# PIPE 209 REVISIONS

Bennington AC NH 019-1 (54)  
Pipe 209 Outlet Plan View  
Stone Fill Type II & Geotextile Fabric  
February 27, 2013  
Calculated by GPI *CW*  
Scale 1:100

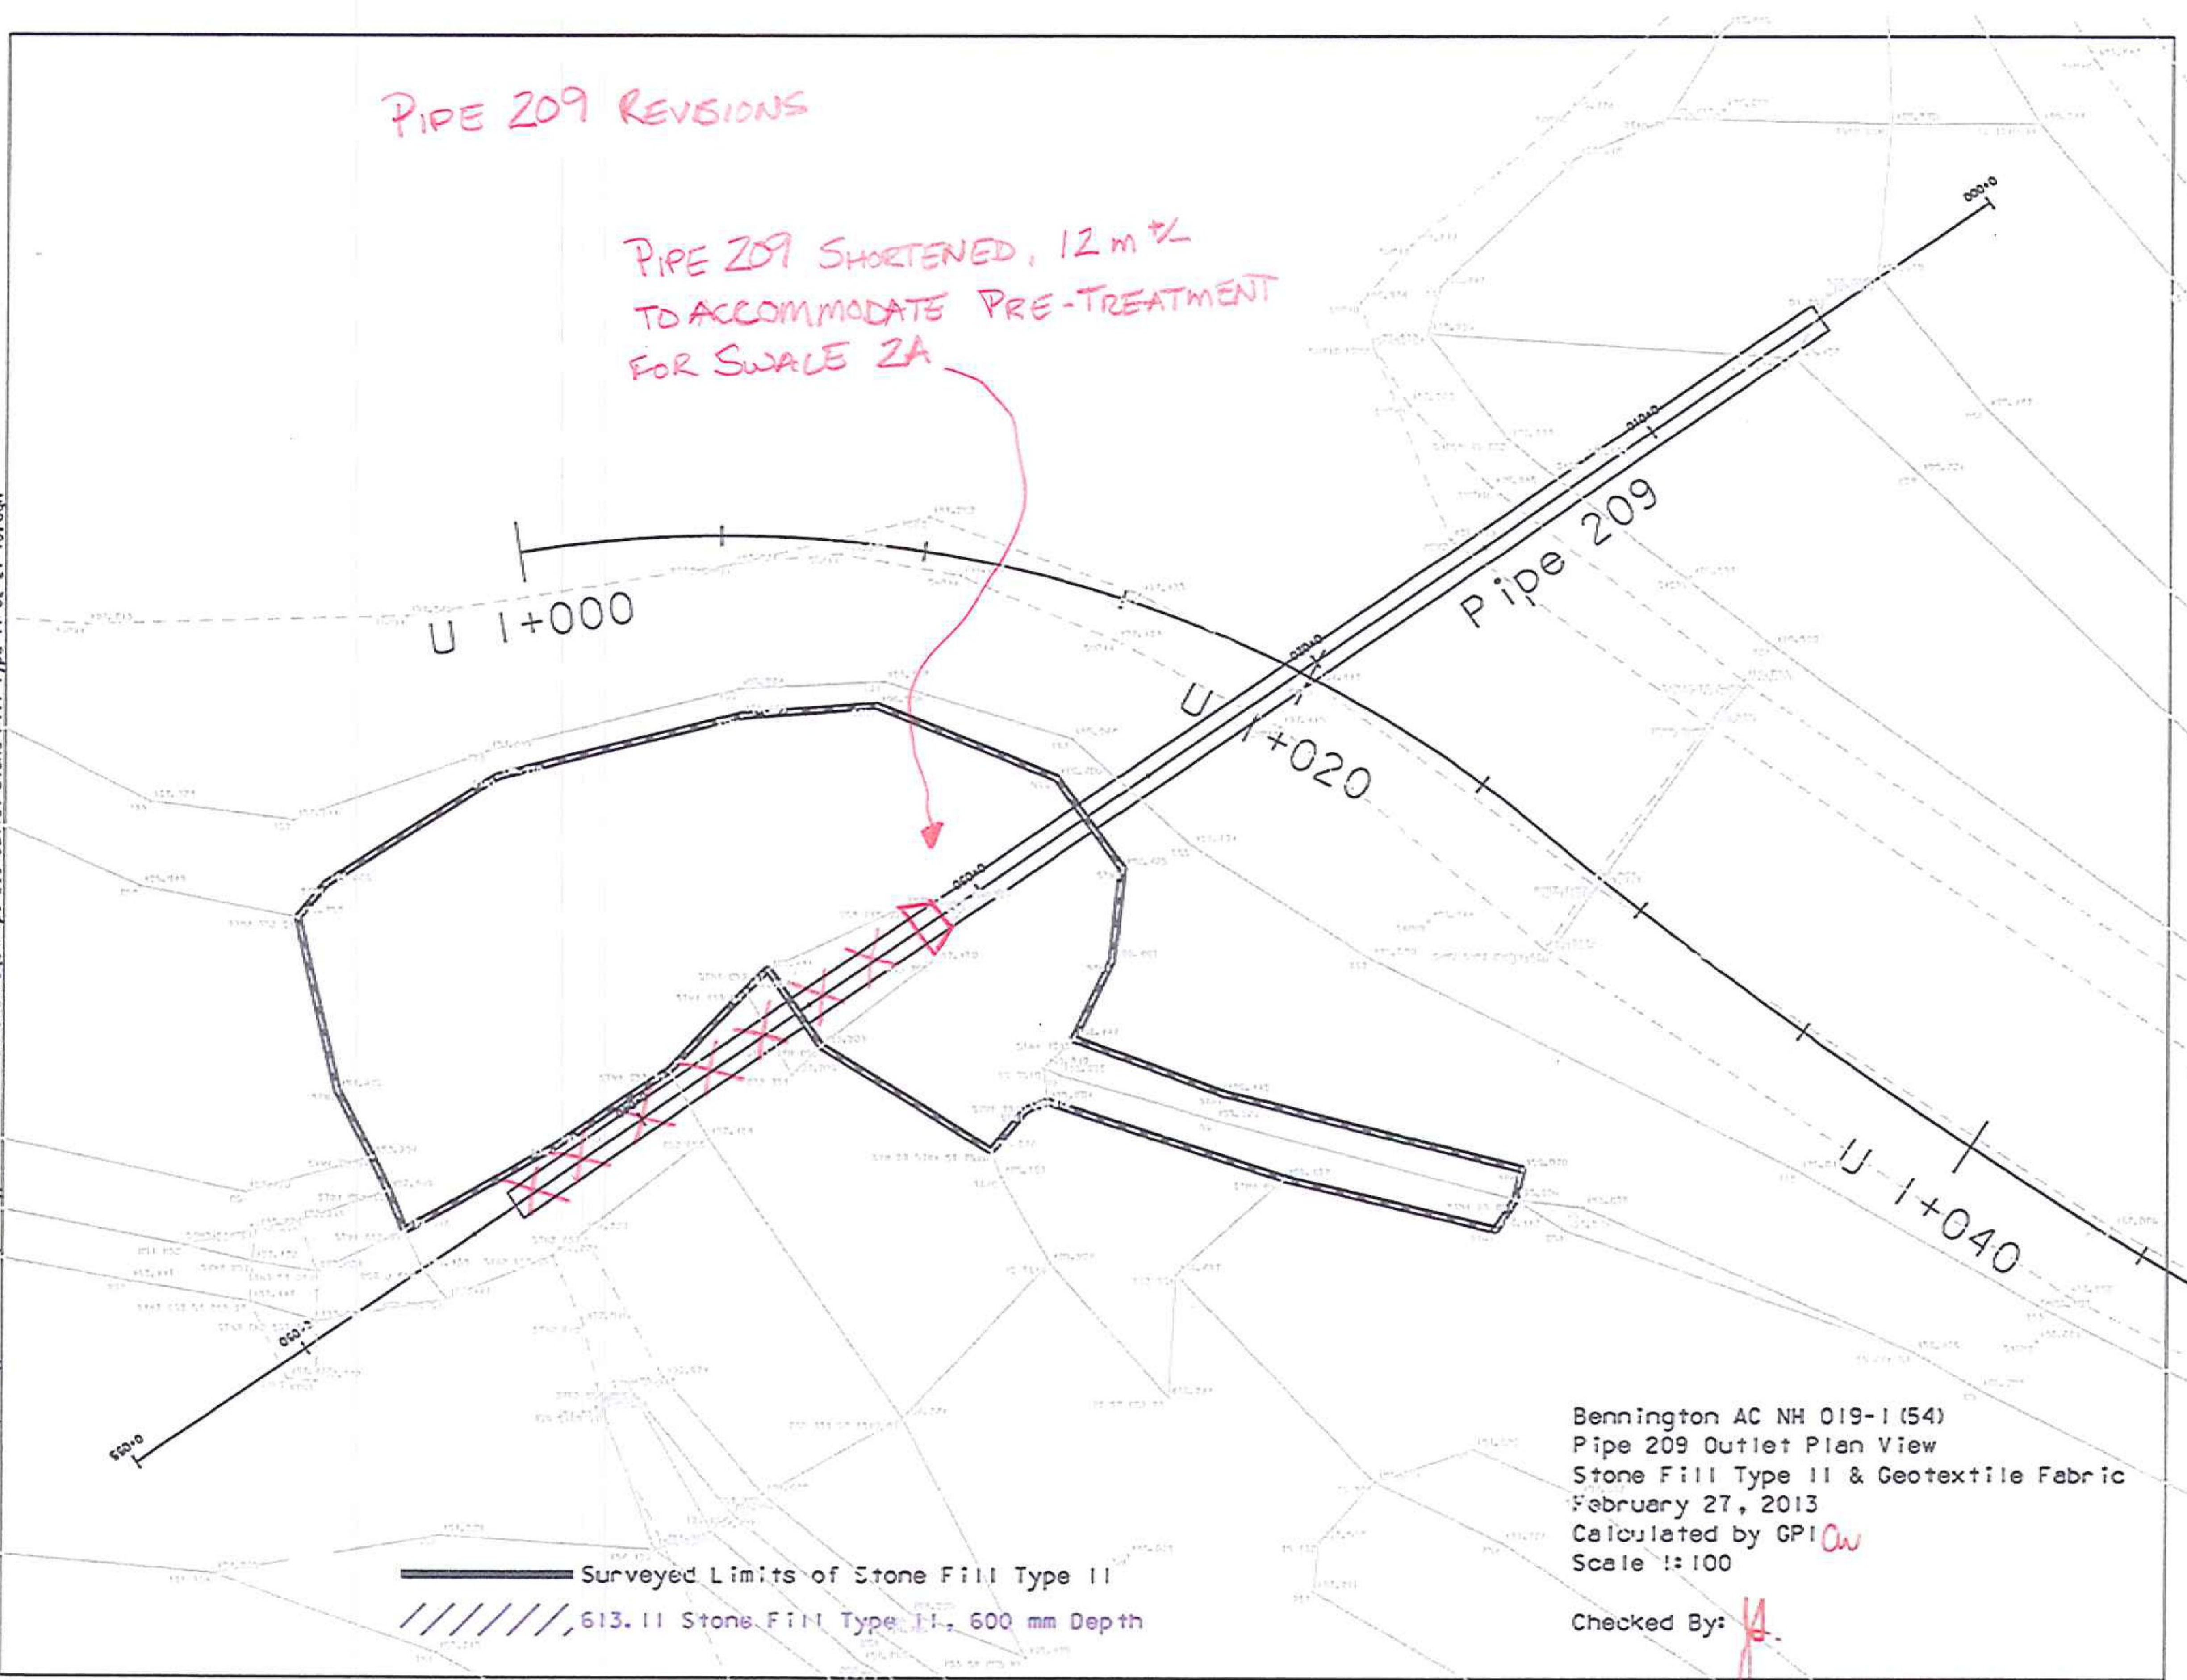
PIPE 209 SHORTENED, 12 m +/-  
TO ACCOMMODATE PRE-TREATMENT  
FOR SWALE 2A
